Access Compliance Report

Public Rights-of-Way

(Curb Ramps)

Intersection ID: 11739	Main Street: W_9TH_ST	Cross Street: N_CHURCH_ST	Location: W
ADA ID: 96339040AC58	Ramp Type: PerpDiag	Initial Pass/Fail: Fail	Overall Compliance: No
			Severity Score: 13.75

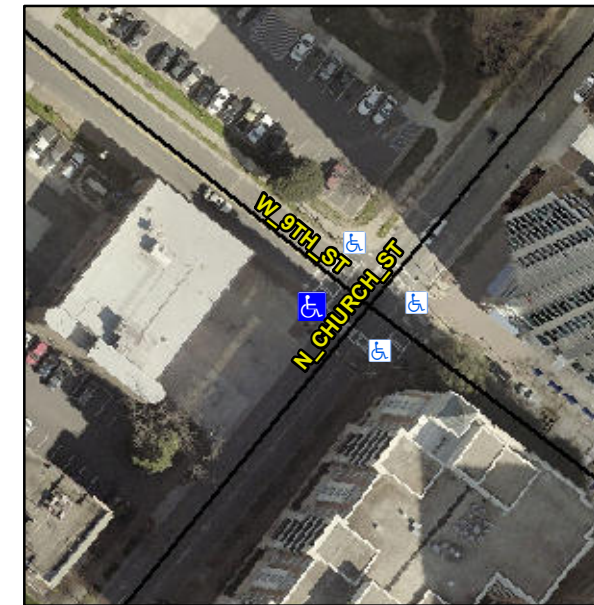
Not Found, R304.2.2, R304.5.3

Compliance	Description	Data	Compliance	Description	Data
N/A	Ramp Length (in)	62.0	No	Ramp Slope (%)	8.9
Yes	Ramp Width (in)	58.0	No	Ramp XSlope (%)	2.1
N/A	Flare Type LT	N/A	N/A	Flare Type RT	N/A
N/A	Flare Slope LT (%)	N/A	N/A	Flare Slope RT (%)	N/A
N/A	Flare Traversable LT?	N/A	N/A	Flare Traversable RT?	N/A
N/A	Landing Length (in)	N/A	N/A	DWS Provided?	N/A
N/A	Landing Width (in)	N/A	N/A	DWS Contrast?	N/A
N/A	Landing Slope (%)	N/A	N/A	DWS Length (in)	N/A
N/A	Landing X Slope (%)	N/A	N/A	DWS Full Width?	N/A
N/A	Landing Curb? (Y/N)	N/A	N/A	DWS Offset (in)	N/A
N/A	Shared Landing?	N/A			
N/A	Gutter Ponding?	N/A	N/A	Gutter Slope (%)	N/A
N/A	Gutter Lip Ht (in)	N/A	N/A	Gutter X Slope (%)	N/A
N/A	Painted X Walk1?	Yes	N/A	Painted X Walk2?	Yes
	X Walk 1 Direction	To SE		X Walk 2 Direction	To NE
N/A	X Walk 1 Width (in)	59.0	N/A	X Walk 2 Width (in)	110.5
	X Walk 1 Slope (%)	4.7		X Walk 2 Slope (%)	5.7
	X Walk 1 X Slope (%)	1.8		X Walk 2 X Slope (%)	2.6

Remove & Replace Curb Ramp With Two New Directional Ramps or Equivalent.
